**Town of Kittery
Planning Board Meeting
February 9, 2023**

ITEM 2 – 39 Badgers Island, Sketch Plan Review – Minor Subdivision

Action: hold public hearing: Pursuant to §16.4 Land Use Regulations and §16.9.3 Shoreland Development Review requirements of the Town of Kittery Land Use and Development Code, owner applicant B.I.W. Group, LLC and agent Chris Atwood Otter Creek homes with Ambit Engineering propose to subdivide the 0.48-acre parcel identified as Lot 38 of Tax Map 1 into 4 residential condominiums. The property is located at 39 Badgers Island West, in the Mixed-Use Badgers Island Zoning District (MU-BI) and Shoreland Overlay Zone (OZ-SL-250’).

UTILITY PLAN **C3**

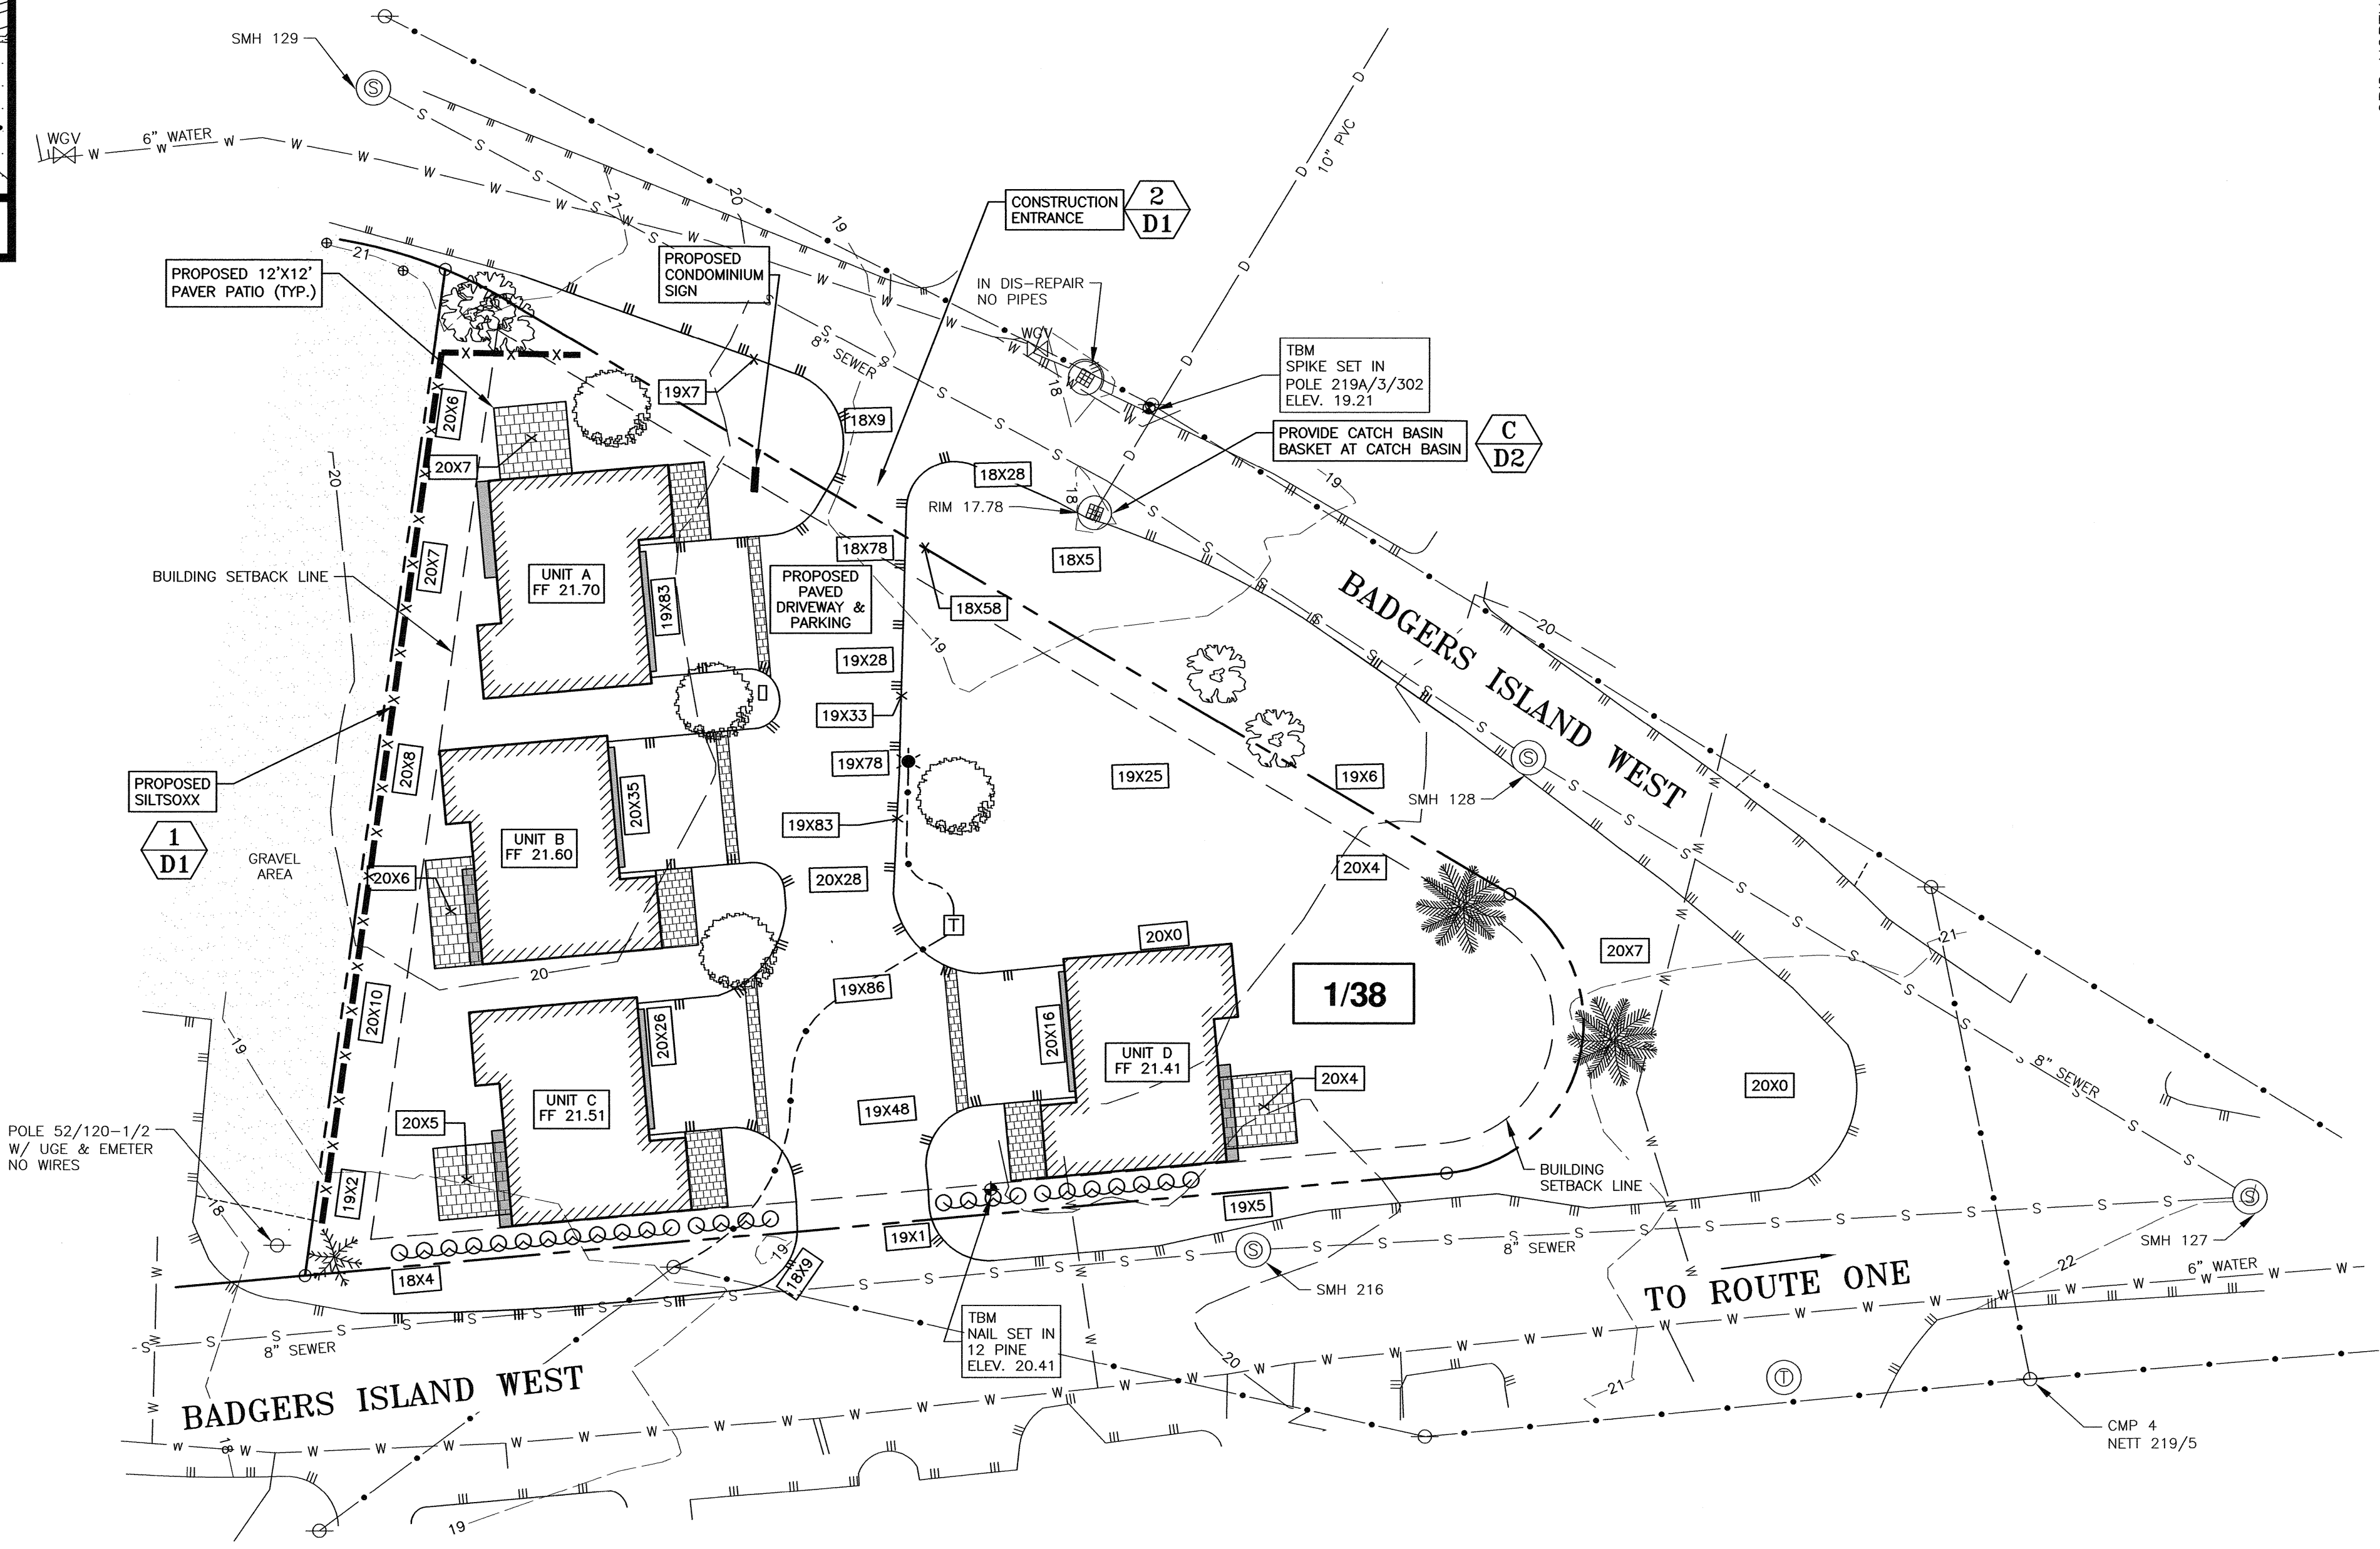
- Utility Plan C3 – This plan shows the utilities required to service the proposed buildings. The plan has tables with the proposed elevations. **Revised entrance location. Added Note 9 and revised water service notes to include sprinkler connection.**

GRADING PLAN **C4**

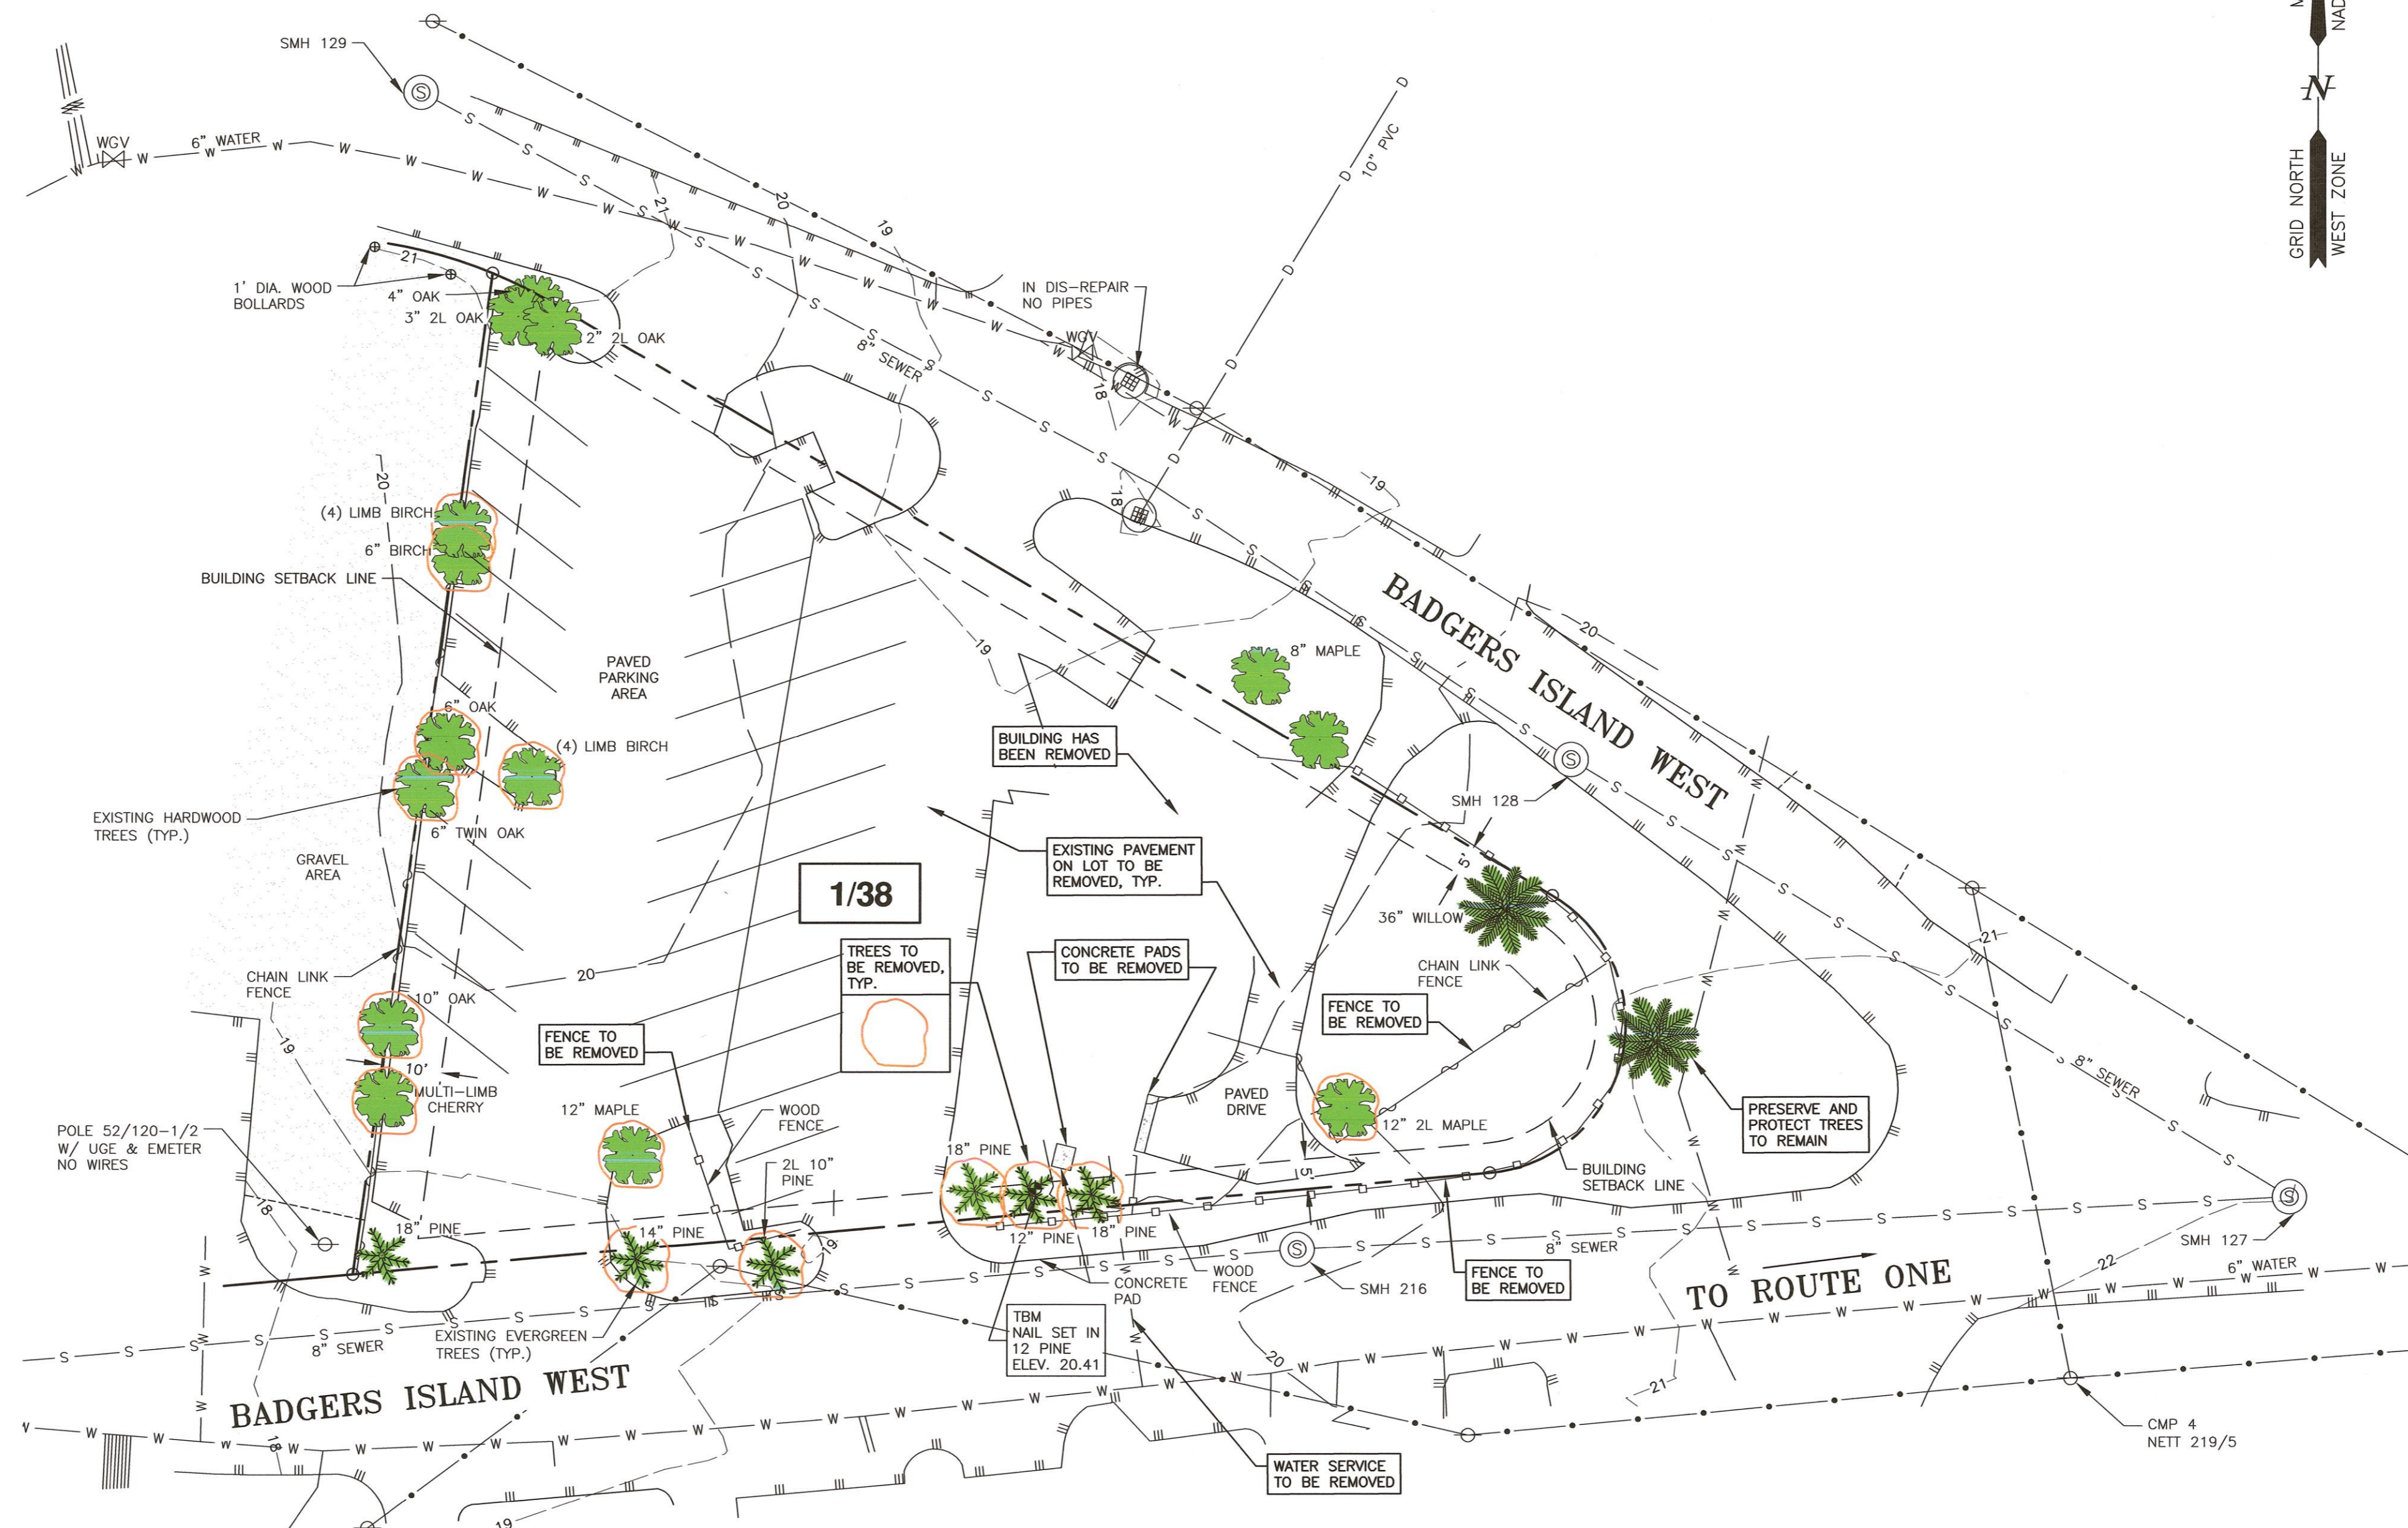
- Grading Plan C4 – This plan shows the proposed site grading. **Revised entrance location and added spot grade.**
- Demolition Plan C5 – This plan shows the proposed demolition taking place on the property. **No change.**
